Access Compliance Report

Public Rights-of-Way

(Curb Ramps)

Intersection ID: 11650	Main Street: W_10TH_ST	Cross Street: N_CHURCH_ST	Location: S
ADA ID: 2E493BB48F1D	Ramp Type: PerpDiag	Initial Pass/Fail: Fail	Overall Compliance: No
		Severity Score: 12.5

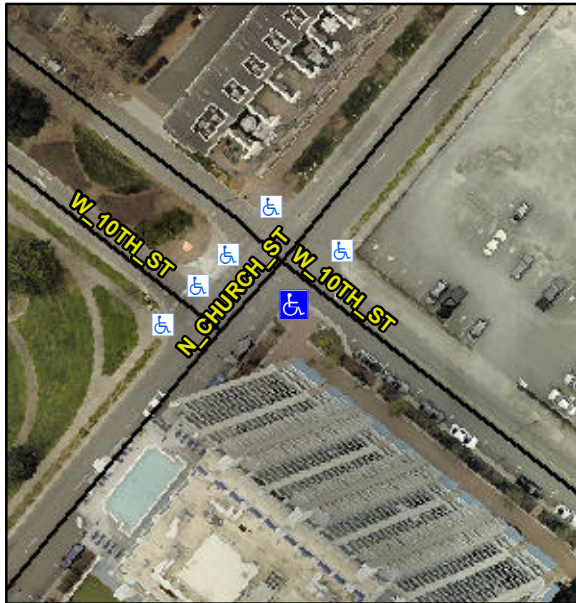
R304.2.2

Compliance	Description	Data	Compliance	Description	Data
N/A	Ramp Length (in)	68.0	No	Ramp Slope (%)	9.2
Yes	Ramp Width (in)	48.0	Yes	Ramp XSlope (%)	1.3
N/A	Flare Type LT	N/A	N/A	Flare Type RT	N/A
N/A	Flare Slope LT (%)	N/A	N/A	Flare Slope RT (%)	N/A
N/A	Flare Traversable LT?	N/A	N/A	Flare Traversable RT?	N/A
N/A	Landing Length (in)	N/A	N/A	DWS Provided?	N/A
N/A	Landing Width (in)	N/A	N/A	DWS Contrast?	N/A
N/A	Landing Slope (%)	N/A	N/A	DWS Length (in)	N/A
N/A	Landing X Slope (%)	N/A	N/A	DWS Full Width?	N/A
N/A	Landing Curb? (Y/N)	N/A	N/A	DWS Offset (in)	N/A
N/A	Shared Landing?	N/A			
N/A	Gutter Ponding?	N/A	N/A	Gutter Slope (%)	N/A
N/A	Gutter Lip Ht (in)	N/A	N/A	Gutter X Slope (%)	N/A
N/A	Painted X Walk1?	No	N/A	Painted X Walk2?	No
	X Walk 1 Direction	To NE		X Walk 2 Direction	To NW
N/A	X Walk 1 Width (in)	N/A	N/A	X Walk 2 Width (in)	N/A
	X Walk 1 Slope (%)	1.6		X Walk 2 Slope (%)	0.9
	X Walk 1 X Slope (%)	2.0		X Walk 2 X Slope (%)	0.2

Remove & Replace Curb Ramp With Two New Directional Ramps or Equivalent.
